SPRING HILL
MUNICIPAL PLANNING COMMISSION
WORK SESSION AGENDA
Monday, August 22, 2016
199 Town Center Parkway
5:30 PM

TO:	Spring Hill Planning Commission
FROM:	Dara Sanders, Planning Director
MEETING:	August 22, 2016
SUBJECT:	STP 224-2016 (2210 Spedale Court)

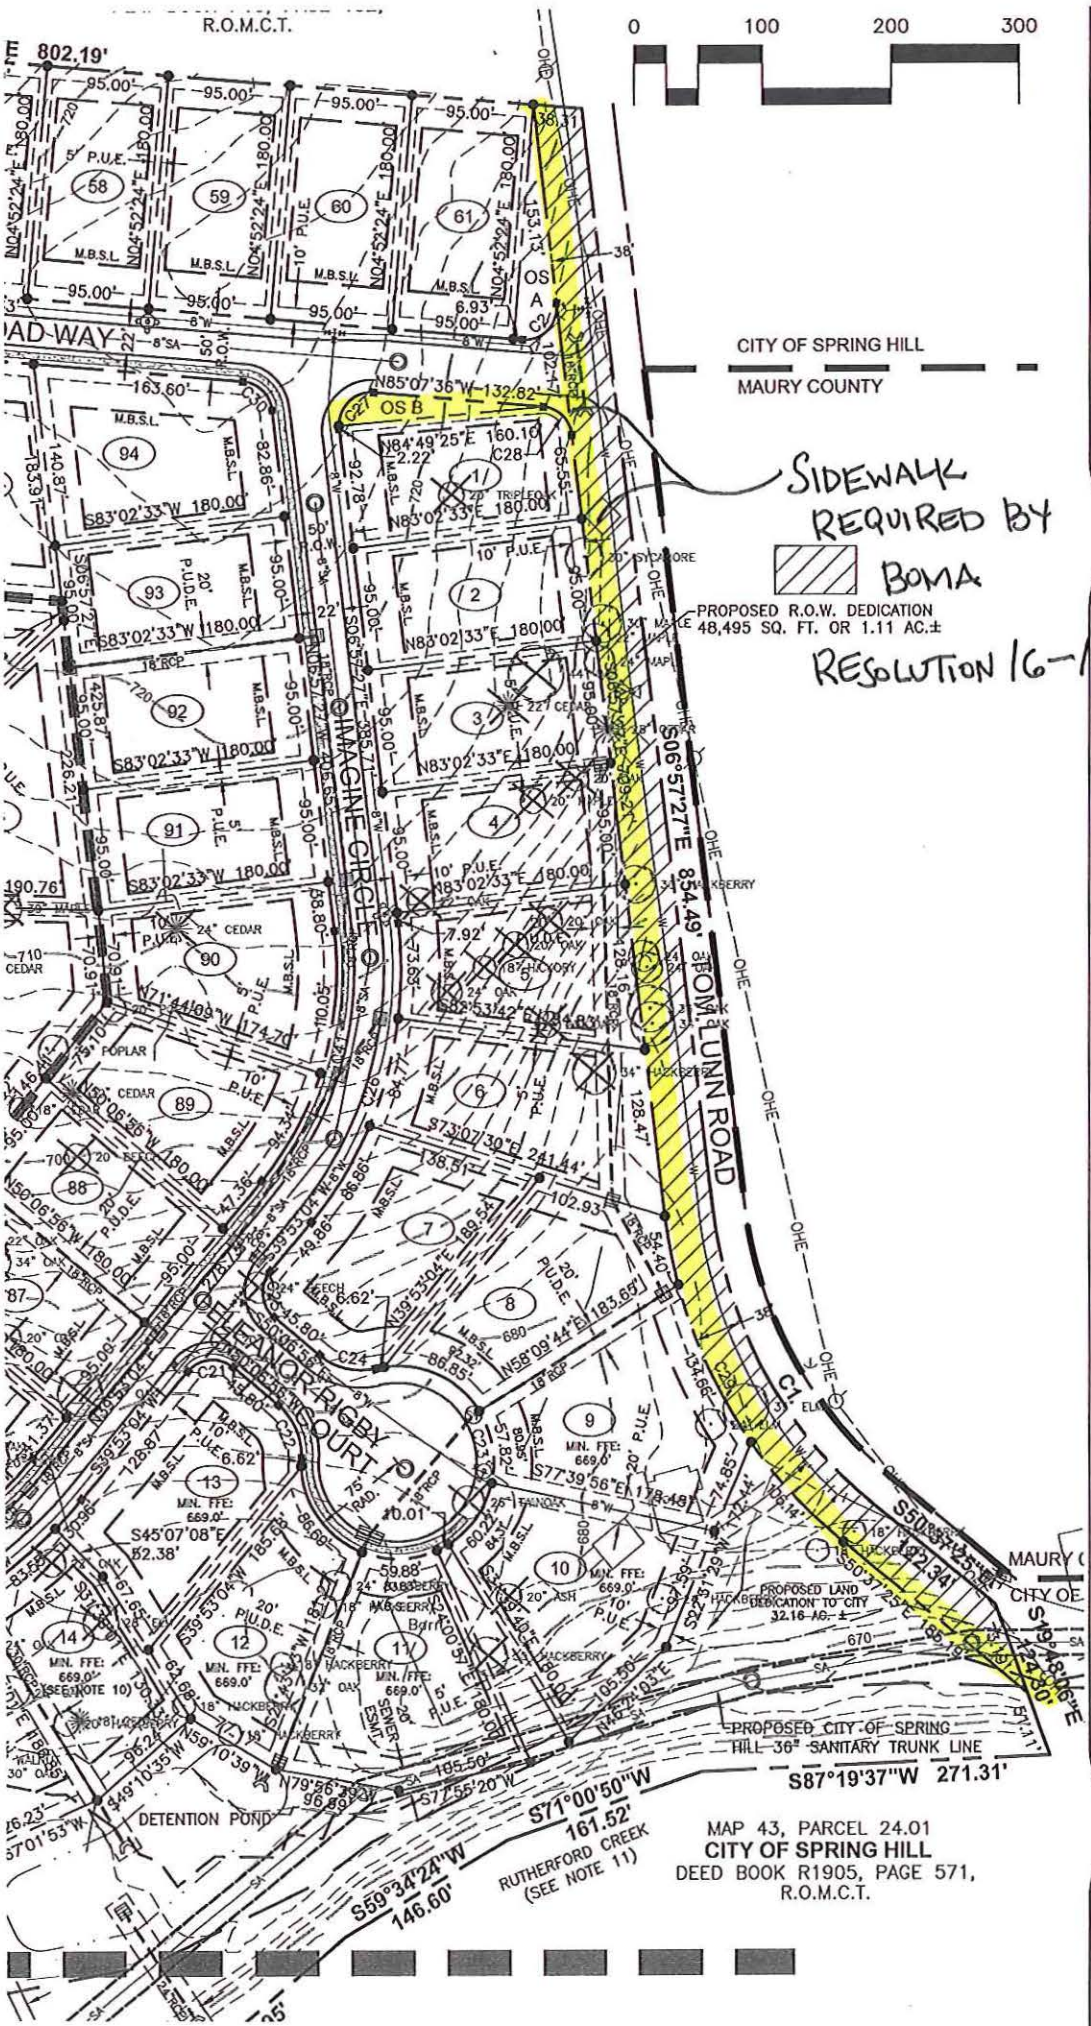
Street and sidewalk: Pursuant to the conditions of NCP 190-2016 and RES 16-105, right-of-way dedication along the property's frontage onto Tom Lunn Road shall reflect the minimum right-of-way requirements for a Collector street in the City's Major Thoroughfare Plan, and the applicant shall be assessed a fee in-lieu of street improvements to Tom Lunn Road to include the cost of milling and overlay.

- Add ADA ramp at Abbey Road and Imagine Circle
- Show Tom Lunn improvements
- Road connection to northern property along Road B
- Show creek depth in sewer profile between structures A5 and A6
- Add General Note that all signage is to be per MUTCD regulations
- Add General Note that CCTV of sewer lines is required

Sketch Plan

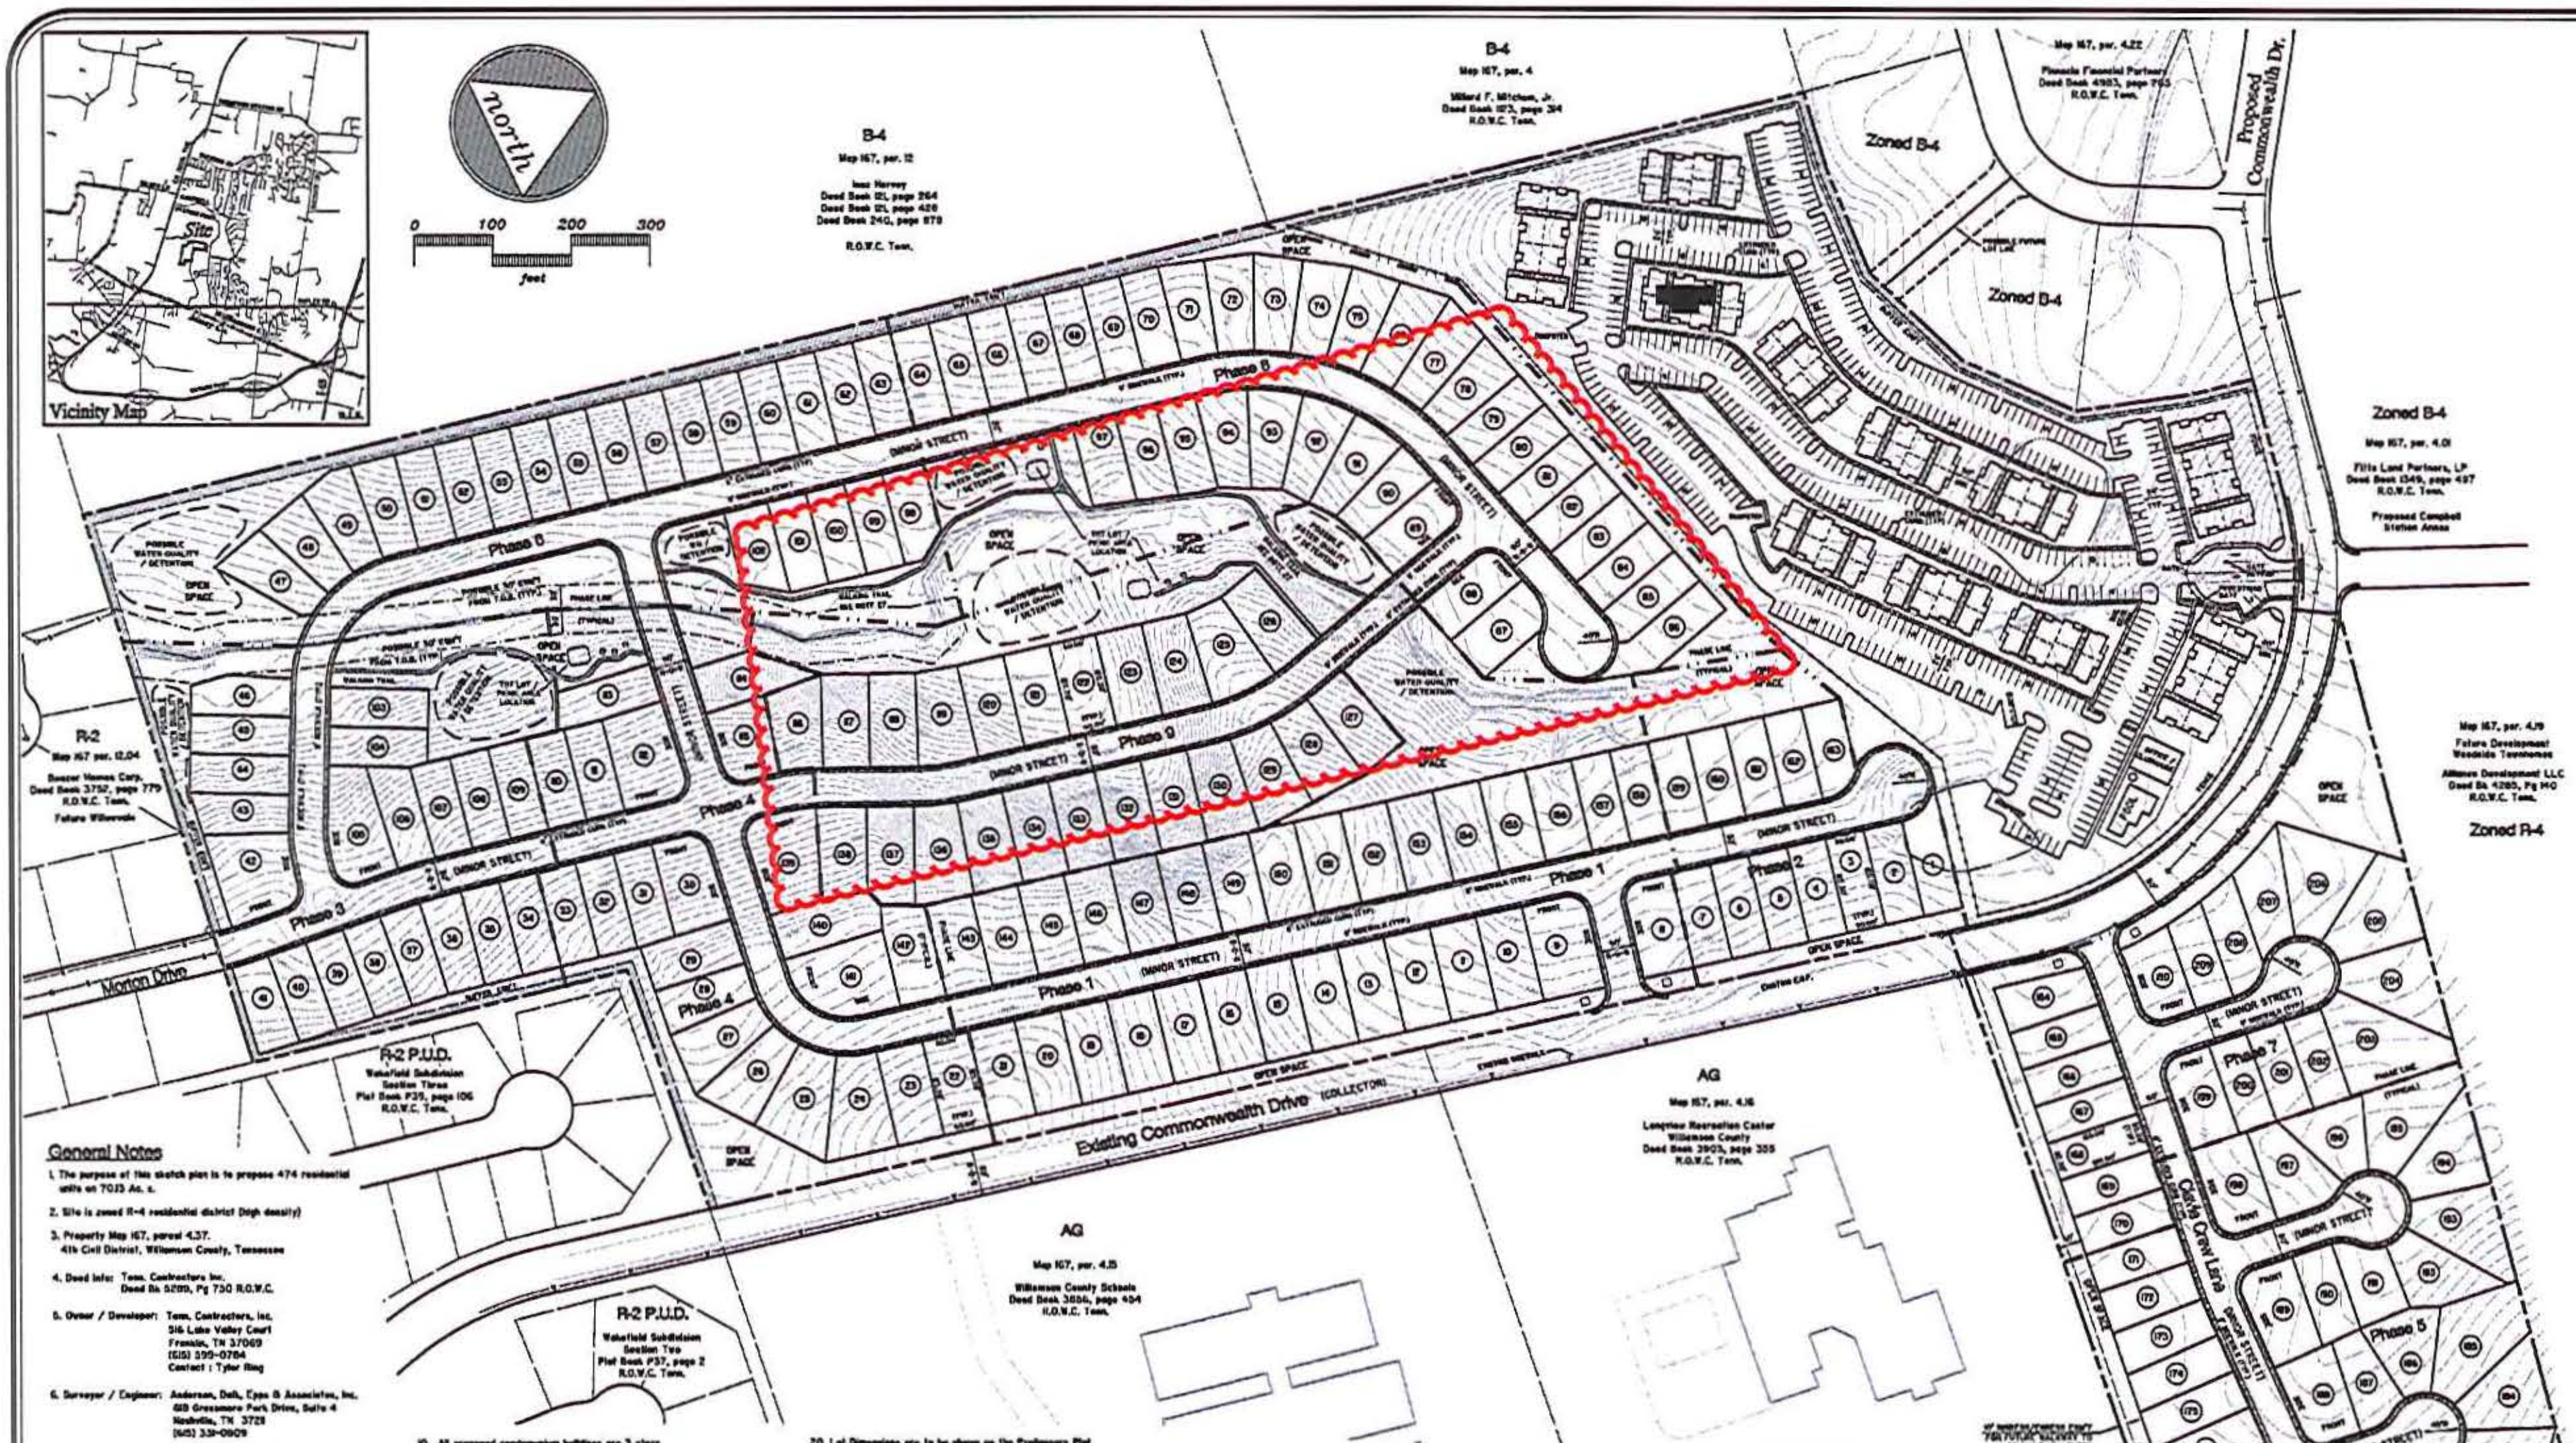
Bicycle and Greenway Plan: This project boundary is not impacted by the Bicycle and Greenway Plan. HOwevwer, the applicant proposeds to construct a trail that would provide pedestrian circulation within a large open space area for the neighborhood and would eventually provide a pedestrian crossing over a stream traversing through the center of the neighborhood.

- Add General Note that all signage is to be per current MUTCD
- Add General Note that CCTV of sewer lines is required
